UNITED STATES PATENT AND TRADEMARK OFFICE

10/593,988

Office Action Summary	Application No. 10/593,988	Applicant(s) SCHRAMM, PETER	
	Examiner CARLOS GAMINO	Art Unit 1793

DETAILED ACTION

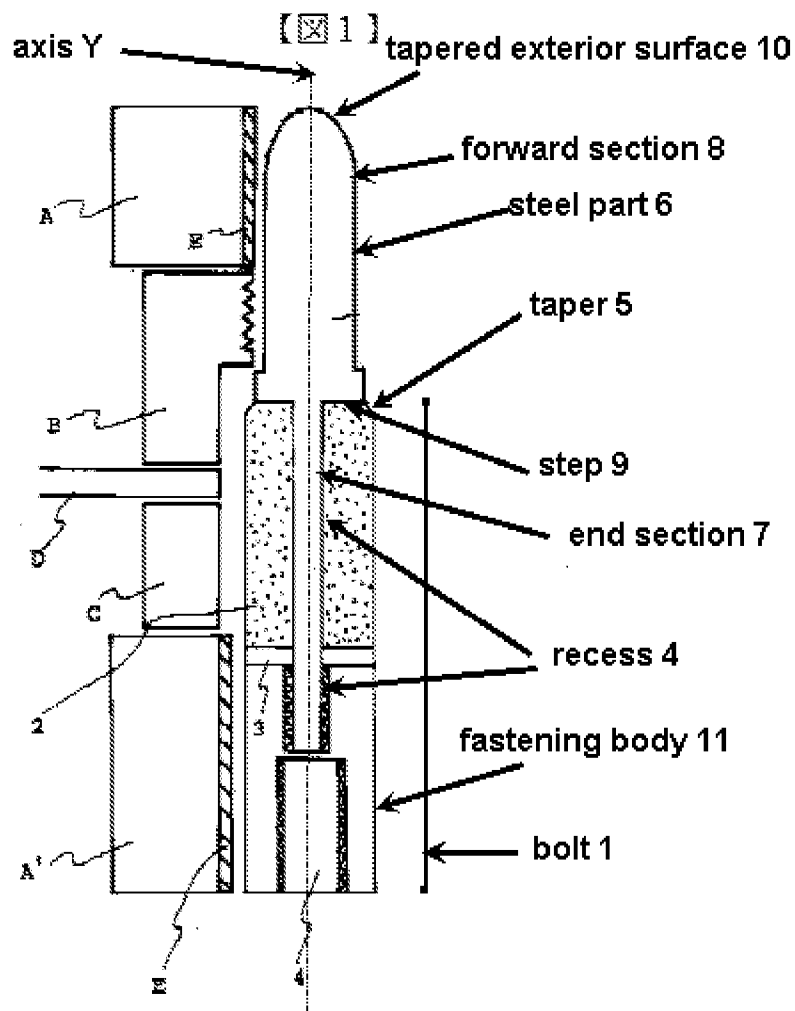
Regarding claim 11, Takuma discloses:

a bolt [bolt 1; for all reference numbers refer to the above figure] having an exterior surface that is substantially parallel to a longitudinal axis of the bolt and that can be introduced into a bore in at least one component,

said bolt including or containing wear-resistant sintered material [ceramic part (2) can be made from sintered silicon nitride, alumina, etc.; abstract and paragraph 0005] and including a recess [recess (4)] at a forward end thereof; and

a tip [steel part (6); abstract] comprised of metal arranged at the forward end of said bolt,

the tip including an end section [end section (7)] which engages in said recess of said bolt,

a direct connection between said end section of said tip and said recess in said bolt existing in a connecting area provided at the forward end of said bolt which extends only over a portion of an entire length of said bolt [the above figure shows that the end section is in direct connection with the recess],

said tip further including a forward section [forward section (8)] which projects axially out of said bolt,

a transition area [taper (5)] being interposed between the forward section of said tip and the forward end of said bolt,

said transition area tapering to said forward section of the tip in a manner such that the receiving element has a stepped exterior contour [taper (5) tapers towards the tip and forms a stepped exterior contour],

said forward section having a maximum external diameter that is less than a corresponding exterior diameter of said bolt by a prescribed amount [the diameter of forward section (8) is less than that of the bolt (1) by a prescribed amount; also see paragraph 0007].

wherein a step [step (9)] is provided between said forward section and said end section of said tip that defines an axial stop with respect to said bolt.

wherein said forward section has an exterior surface [tapered exterior surface (10)] that tapers substantially conically toward a free end with a prescribed takeout angle.

wherein said exterior surface of said transition area has a transition takeout angle that is substantially greater than the substantially conical takeout angle of said forward section [the angle of taper (5) is at some point is greater than that of surface (10)].
